DETAILED ACTION

Art Unit: 2861

FIG. 1

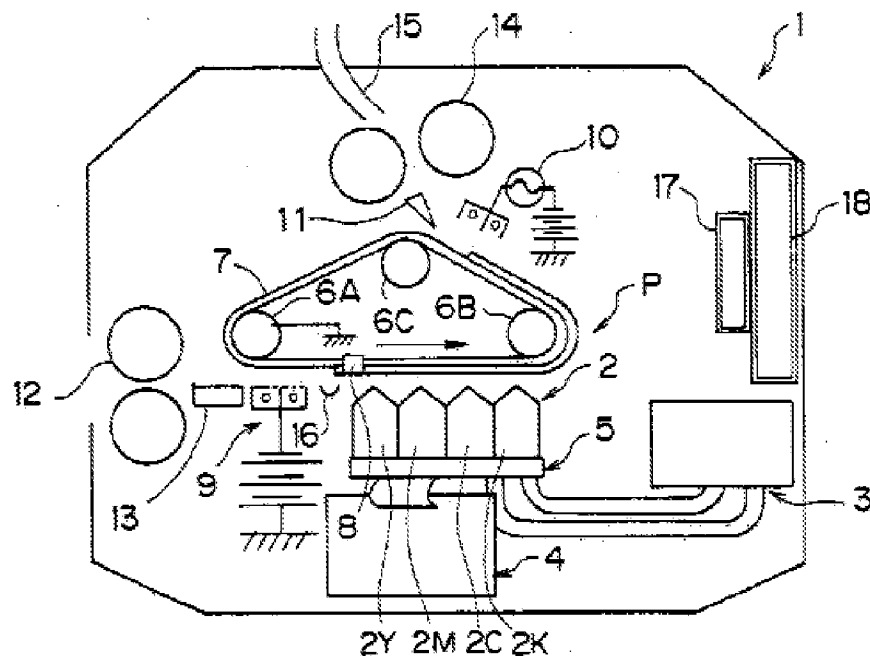
- c. As related to independent **claim 4**, Nakazawa et al. teach an ink-jet printer (Nakazawa et al. – Title) in which recording is executed by discharging inks of a plurality of colors from a discharge opening as droplets of ink to be attached onto a recording material (Nakazawa et al. – Background, Paragraph 5; Summary, Paragraphs 8 & 11; Detailed Description, Paragraph 58 and Figure 1, Reference #2Y, #2M, #2C & #2K, shown below).

d. Continuing with **claim 4**, Nakazawa et al. goes on to teach the case where the interval between a discharge of an ink of a first color and a discharge of an ink of a second color is 200 mS or less [i.e. $15\text{kHz} = 67\mu\text{S}$ which is less than 200mS] (Nakazawa et al. – Examples, Page 15, Paragraph 138, Specifically the 7th line from the end of the Paragraph), inks whose surface tension is 25 to 45 mN/m at 23° C. are used for said inks of each color (Nakazawa et al. – Detailed Description, Paragraphs 118 & 120).
